CITY OF ALBUQUERQUE

RE: Slim Chicken
8240 Montgomery Blvd NE
Grading and Drainage Plans
Engineer's Stamp Date: 02/22/21
Hydrology File: G19D004E

Based upon the information provided in your submittal received 04/06/2022, the Grading & Drainage Plan **is not** approved for Building Permit and for action by the DRB on Site Plan for Building Permit. The following comments need to be addressed for approval of the above referenced project:

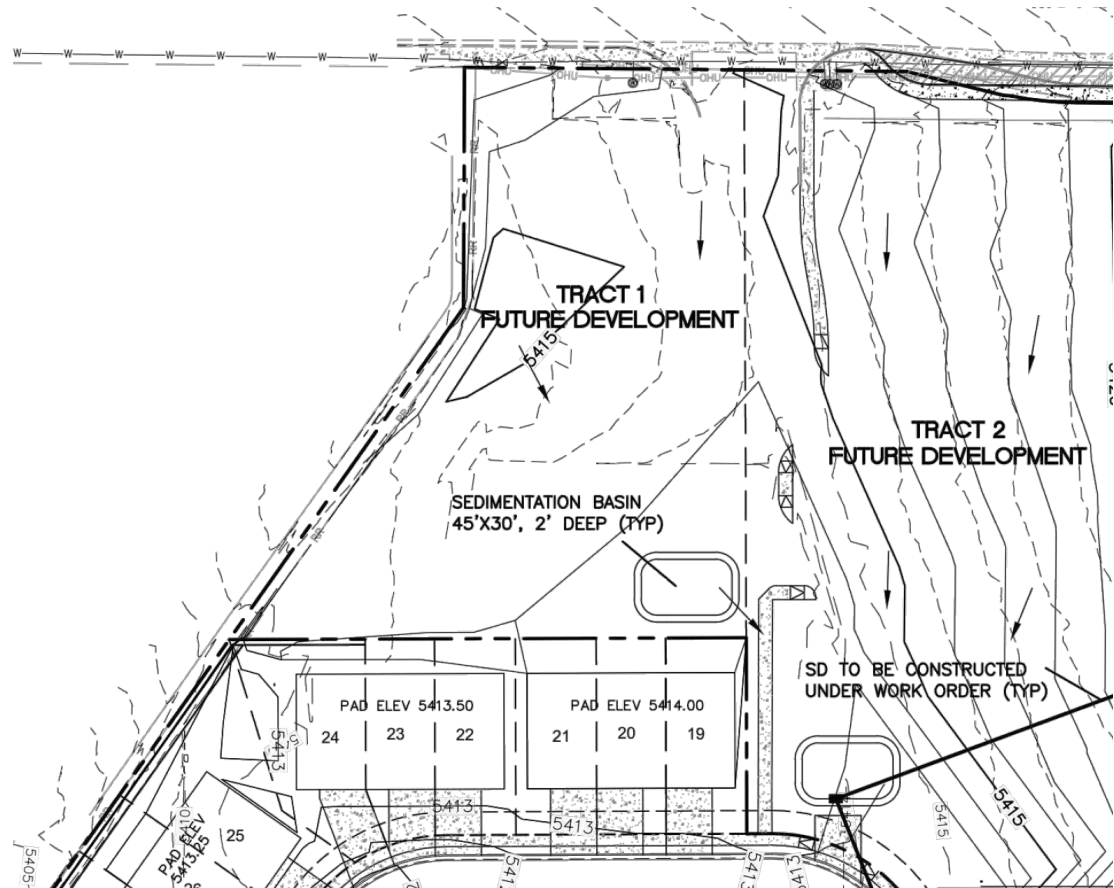
1. Please show the entire scope of the work to be done with this Permit. Below is the Approved Interim Grading & Drainage Plan for this Tract and entrance into Montgomery. Now show all the limits of the entrance. Most of this was demolished so that this site needs to build the entrance with curbs on both sides. The proposed sidewalk along the eastern part of the entrance needs to be labeled, "Sidewalk to be constructed un CPN # 568483. The existing line work within Montgomery needs to be shaded back so that the proposed work pops.

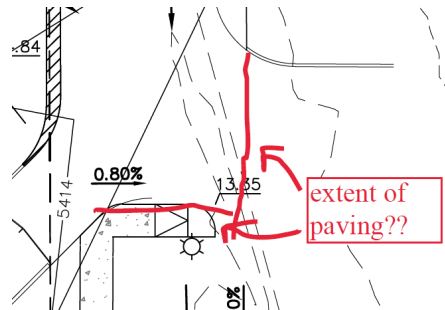
- Please add the flowline at the curb return at the Montgomery entrance.

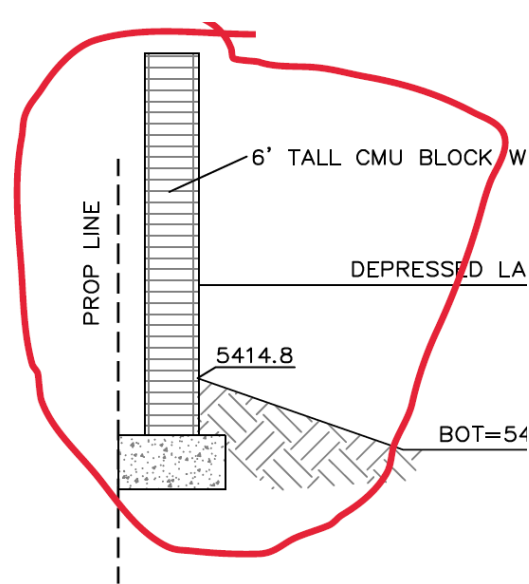
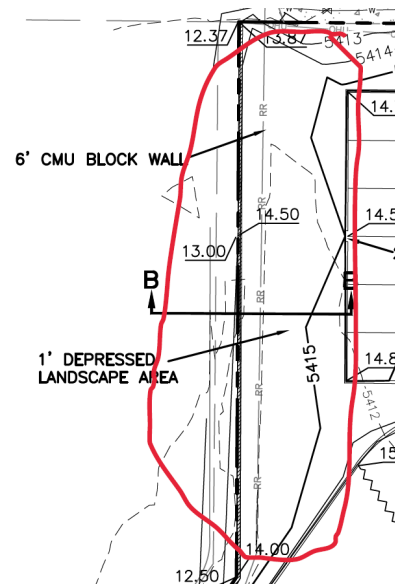
- Where is the extent of the paving along the southeast corner of the development?

- There is a missing CMU block wall on the plan that is shown in Section B-B.

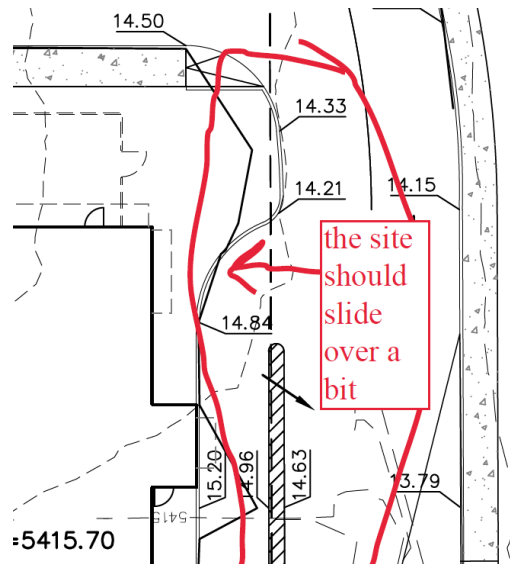
- Noticed that there is paving to be done on Tract B. It also appears that a majority of the drive (access road for the overall commercial) is on Tract B but should still be split between Tract A and Tract B. Please contact Transportation on this issue. Hydrology

will need written letter from the Owner of Tract B authorizing the work to be done within Tract. This letter needs to be notarized.

6. It appears that there is a lot of work on Tract B that should actually be on Tract A. This should slide over a little to make it work.

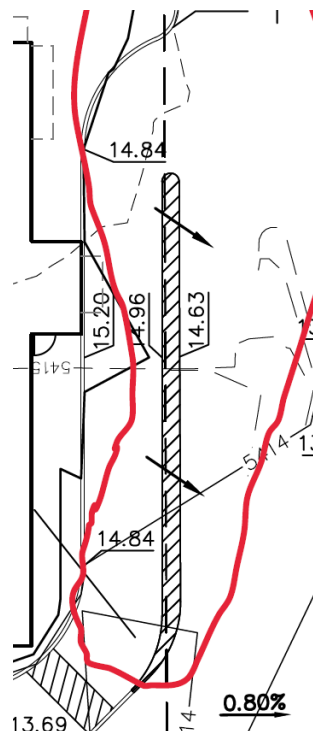
7. The separation between the drive-thru and the oncoming traffic from Montgomery should be a curb and not just stripped. Please contact Transportation for approval.

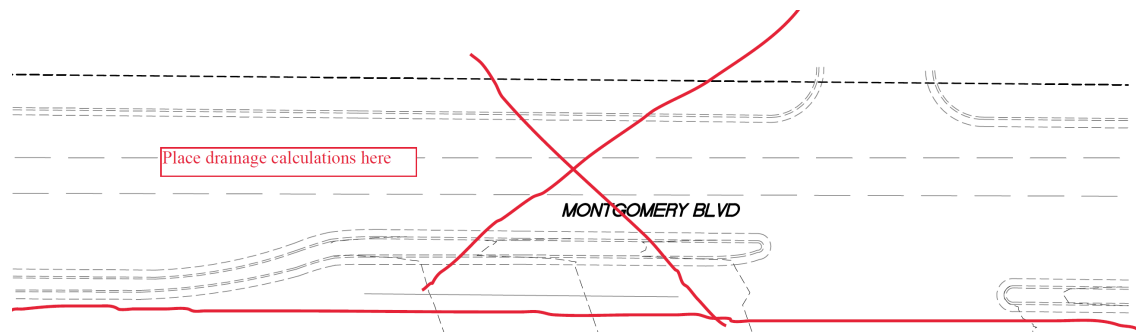
8. Please add both the existing conditions and the proposed condition calculations on the Grading & Drainage Plan. Reference to the overall development drainage manage plan is nice but the calculations are still needed on this sheet. The majority of Montgomery Blvd is not need, so the calculations can be place there.

9. Please provide the weir calculations, per DPM Article 6-16(A), for the curb cuts. A coefficient of 2.7 is typically used for the weir equation $Q = CLH^{2/3}$.

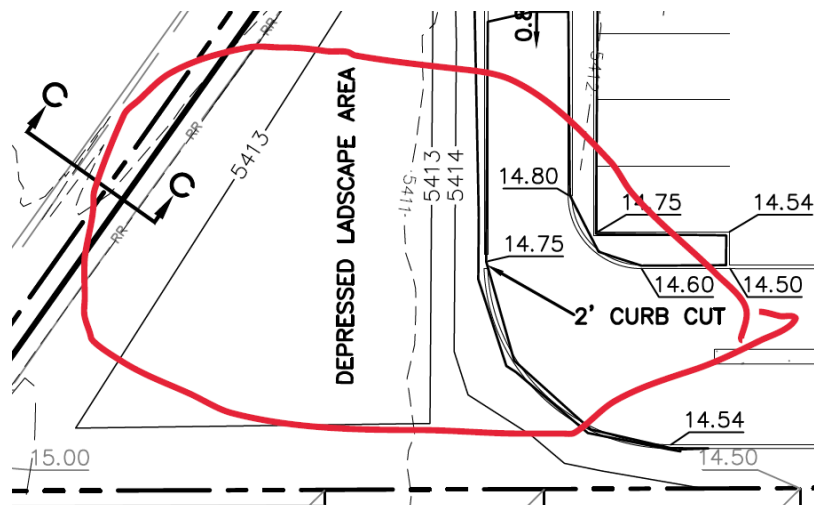
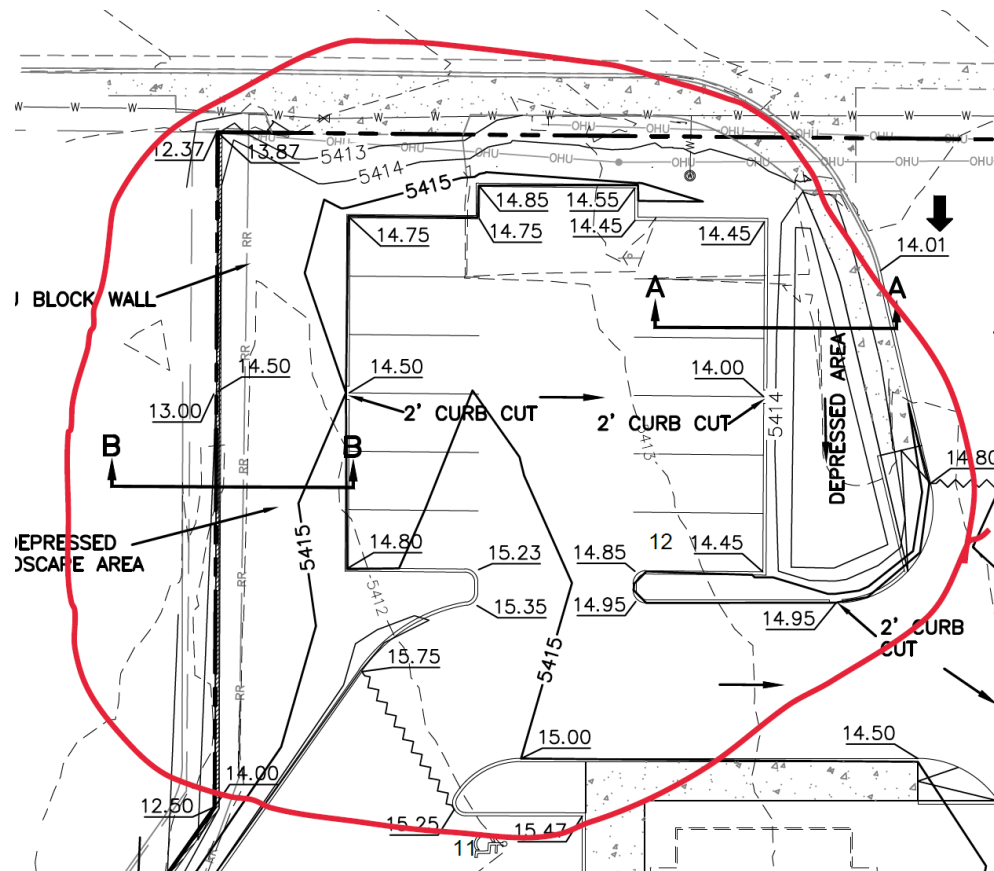
10. The entire Tract A needs to follow the approved overall development drainage management plan. See the wording below form that plan.

COMMERCIAL BASIN "A" AND "B" WILL DRAIN SOUTH TO A PROPOSED DROP INLET LOCATED JUST NORTH OF WYMONT CIRCLE. THOSE FLOWS WILL BE CONVEYED THROUGH STORM SEWER TO THE WATER QUALITY POND. BASIN "C" WILL DISCHARGE TO A PROPOSED DROP INLET AT THE ENTRANCE ON MONTGOMERY AND DRAIN VIA STORM SEWER TO THE DROP INLET THAT CAPTURES BASINS "A" & "B".

This site currently violates this approved plan with curb cuts into depressed landscaping areas that do not drain anywhere or drains into Montgomery Blvd which is not allowed.
